McArthur River Mine

North Overburden Emplacement Facility – Independent Expert Panel Report

Prepared for: *Department of Lands, Planning and Environment, Northern Territory
Government; and McArthur River Mining Pty Ltd*

DOCUMENT CONTROL	
Document Number	R01
Project Number	2023068
File Location	Z: Projects/2023/2023068

Figure 4-14: Location of vertical temperature monitoring bores with bores 32, 33, 34 installed in 2023 in the SW corner of NOEF marked by the yellow arrow.

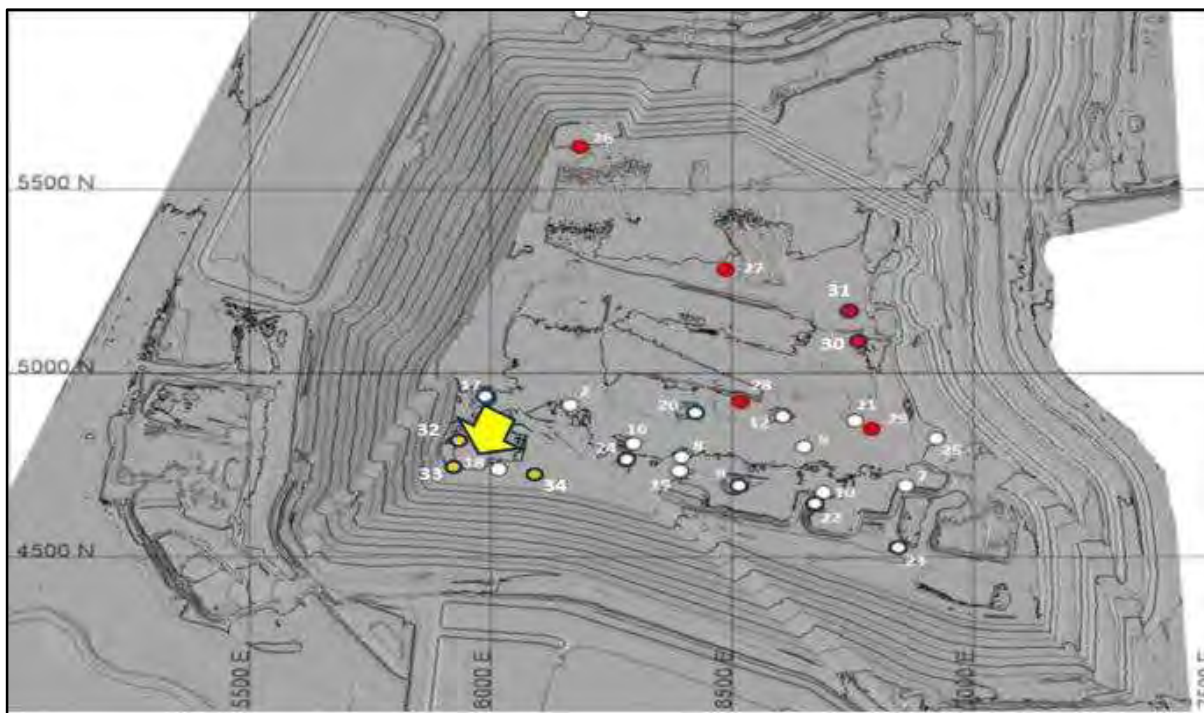
All measured temperatures in the vertical temperature monitoring bores shown in **Figure 4-14** (with the exception of those in bores 32 and 33) remain well below the temperature required to potentially initiate spontaneous combustion (>100 °C) and indicate that the batter geometry and alluvial cover is effective at minimising oxidation of sulfides. Bores NOEF 2023-32 and NOEF 2023-33 show very similar temperature profiles characterised by a general increase in temperature with depth, reaching a maximum of 100 °C and 92 °C at 30 m, which was the maximum depth of these bore installations. The temperature was still increasing at this depth, indicating that there may have been higher temperatures further down in the profile.

The consistently elevated temperature seen in NOEF 2023-32 and NOEF 2023-33 at depth is indicative of ongoing sulfide oxidation at this location, likely resulting from the unfavourable geometry of the area, i.e. the close proximity of batter crest with batters on two sides resulting in higher rates of oxygen ingress. Both bores are located in the pre-2016 parts of the NOEF, which does not benefit from the OMP-EIS design (lower construction lifts, segregation of PAF and reactive PAF, no internal advection barriers) which is likely results in the more elevated temperatures. This reinforces the need for continued vigilance and targeted management of this part of the pre-2016 NOEF and emphasises that the originally planned remedial works and NOEF design should be implemented as soon as cultural approvals are in place.

Figure 4-15: Maximum temperatures recorded in monitoring arrays (Fig 11 in MRM 2025a).

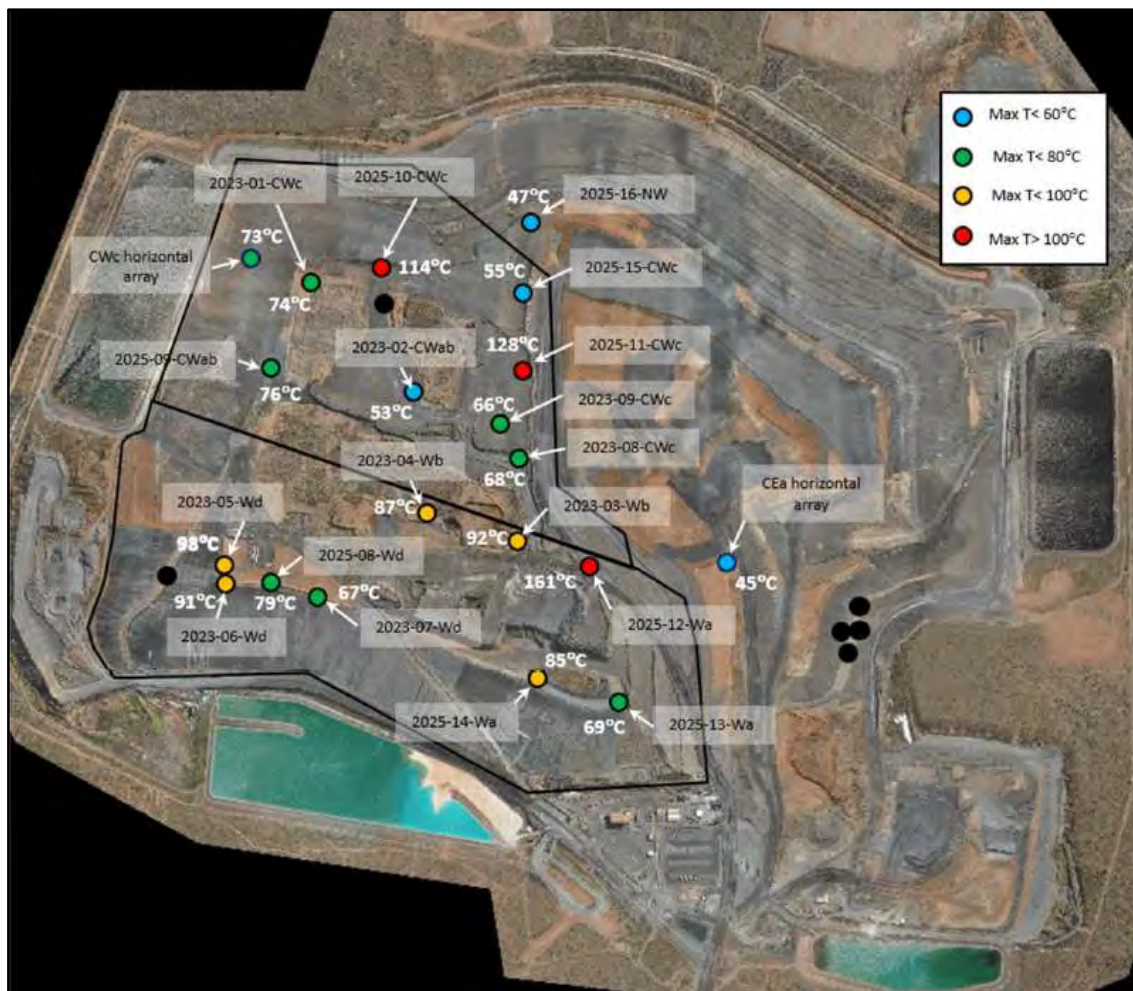
Beside the bore name in **Figure 4-15** is the maximum recorded temperature in the array at that location. The maximum temperature recorded for each of the pre-2025 locations is consistent with that reported above. However, bores 2025-10-CWC and 2025-11-CWC in the new area showed a maximum of over 100 °C (114 and 128 °C respectively).

The elevated temperatures at bores 2023-05-Wd and 2023-06-Wd (formerly 32 and 33) again reported, with the statement that *“All three locations are under investigation to determine the best course of action and what type of controls are required.”*

Figure 4-30: Surprise Creek Fence Diagram – Carpentaria Highway to Barney Creek Diversion (south of NOEF), from KCB (2024a)

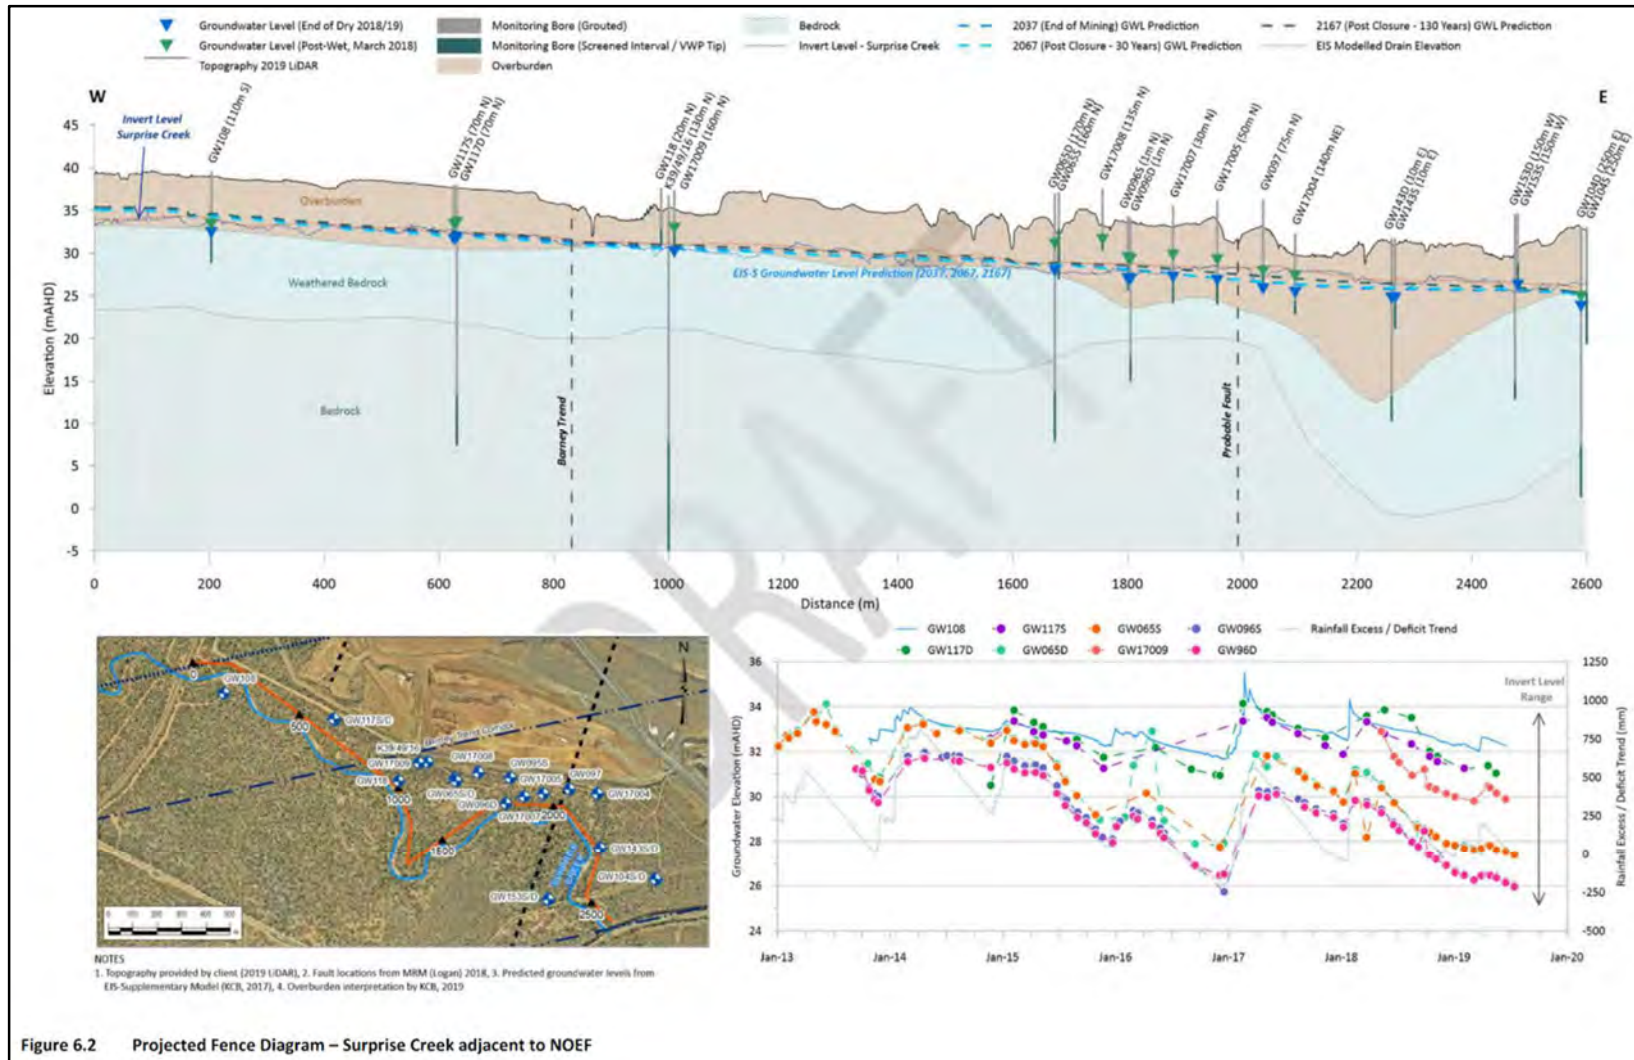
GW96D is located at about chainage 1,800 m and is assumed (based on the section) to be screened within bedrock. The hydrograph for this bore on this fence diagram showed groundwater levels to be consistently above 30 m AHD up to about mid-2015, with two more wet season peaks occurring in 2017 and 2018 to about 30 m AHD. **Figure 4-31** of this report provides a longer record for this bore, which shows groundwater levels at this bore are consistently below 28 m AHD. Lining of SPROD occurred in 2019, and the invert of the Surprise Creek at this location is estimated from the fence diagram at about 28 m AHD. This presents the possibility that post lined SPROD conditions are now lower, and the interaction with the creek has reduced. This aspect of local connectivity should be reviewed in more detail as it is a very important aspect to understanding the potential for seepage interaction from the NOEF to the relatively fast pathway of Surprise Creek.

Figure 4-36: Tough2 Generated Sulfate Concentrations for Basal and Toe Seepage, from KCB (2017)

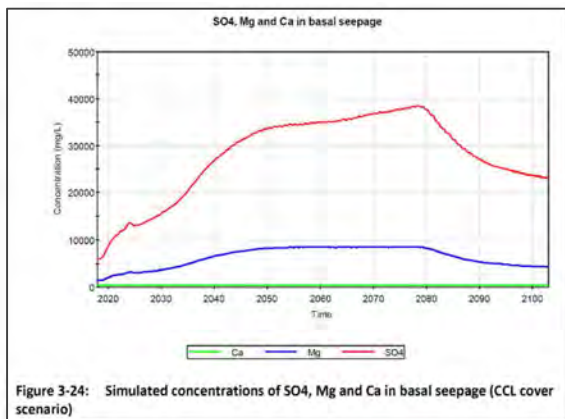
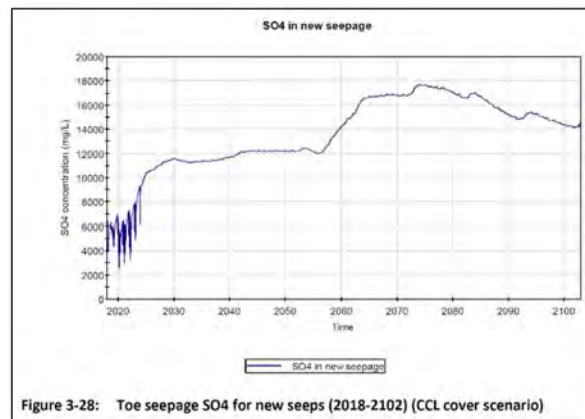
- From **Figure 4-36**, basal seepage sulfate concentrations are expected to peak in around year 2080, at between 35,000 mg/L and 40,000 mg/L, then reduce over the next two decades to about 20,000 mg/L to 25,000 mg/L. Current levels of sulfate in the PRODs as a surrogate of basal seepage quality (KCB, 2024b) are generally 10,000 mg/L or less, however do rise to more than 30,000 mg/L during periods of accumulation.

Figure 4-37: Variability in sulfate source terms applied to the Modflow model domain (KCB, 2025)

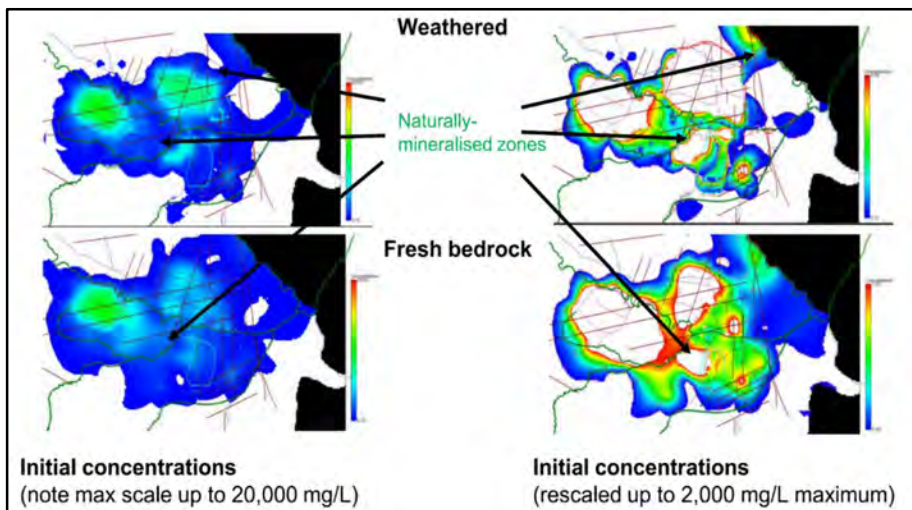
- In the NOEF footprint monitoring bores, sulfate has historically been less than 10,000 mg/L, although some bores are showing levels in recent years of up to 20,000 mg/L.
- Otherwise, sulfate levels are quite variable, and likely an outcome of proximity to seepage impacts from the NOEF and naturally occurring levels, which may be associated with differing rock types and the presence of structure. **Figure 4-37** reflects this spatial variability in the upper right image.

- Sulfate levels generated from predictive modelling, as discussed above, should not be considered a direct or singular outcome of the NOEF. From **Figure 4-37**, it is noted that rock also has areas of high sulfate (>2,000 mg/L, used in starting conditions for simulations). In the area beneath Barney Creek, the Western Fault and an East-West structure parallel and south of the Barney Corridor, have such a noted high sulfate condition. In considering predictions of sulfate source, fate and pathway, it is important to recognise the three dimensionality of the pathways and the abrupt change that structure can impose. This also highlights the relevance of a whole-of-site 3D simulator for groundwater movement and interactions.

Figure 4-39: Example groundwater elevation calibration match to measured data (good – left, poor – right)

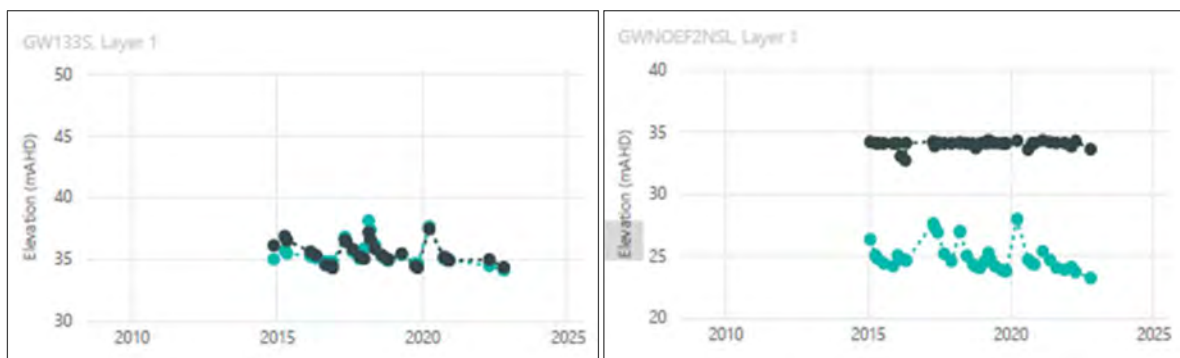
While there are some bores in these data which have not matched observed conditions, generally the predictive capacity of the model appears very good, particularly the case in layers 4 and deeper, representing weathered and upper bedrock and faulted conditions.

Figure 4-49: Mass load comparison – empirical and numerical estimates (KCB, 2024a)

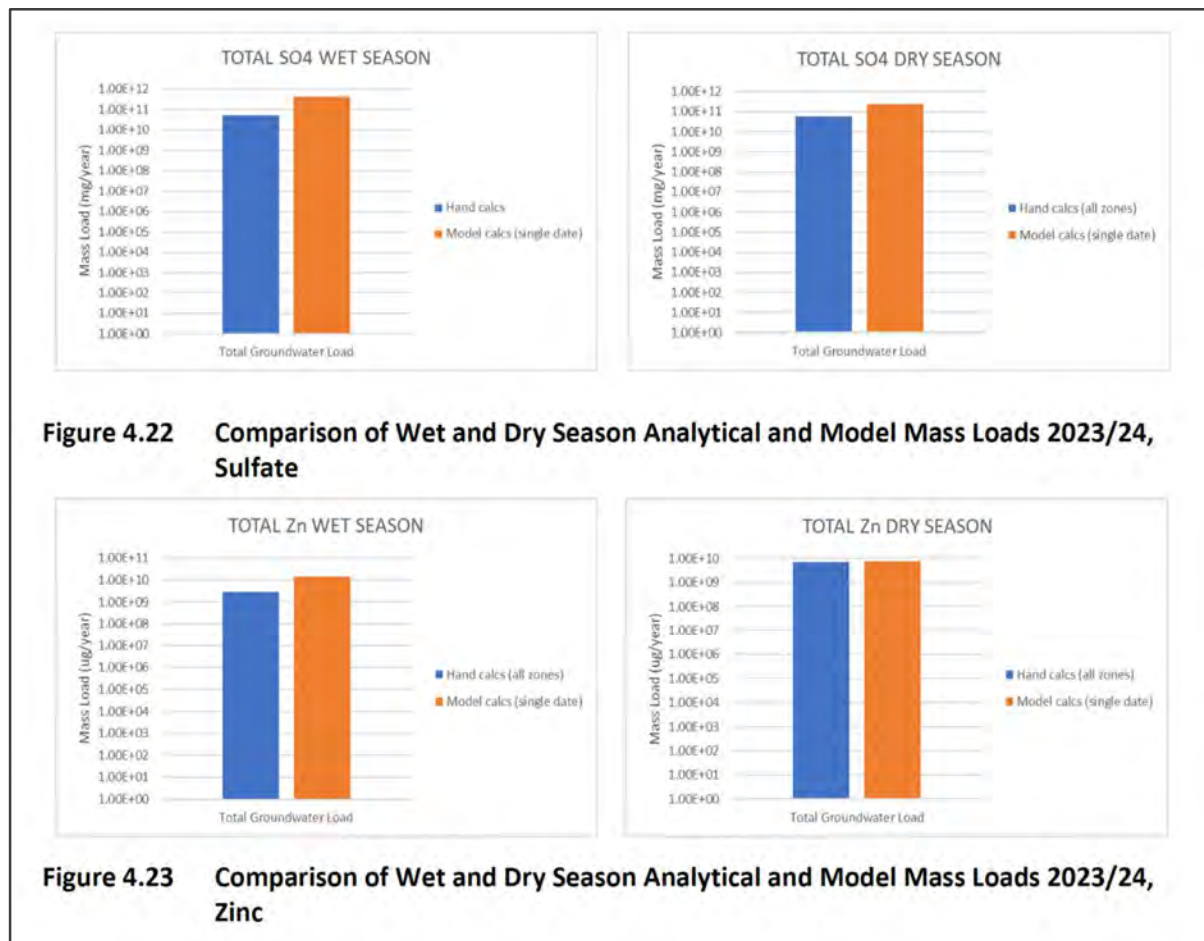
KCB (2024) applied Darcy’s rule to develop a range of loads reporting to the respective river reaches from the NOEF and other mine infrastructure. These are presented as total loads, with the manually derived values compared to the numerically (groundwater model) derived values in **Figure 4-49**. Good correlation is noted; however, the detail of the analytical approach is not presented explicitly.
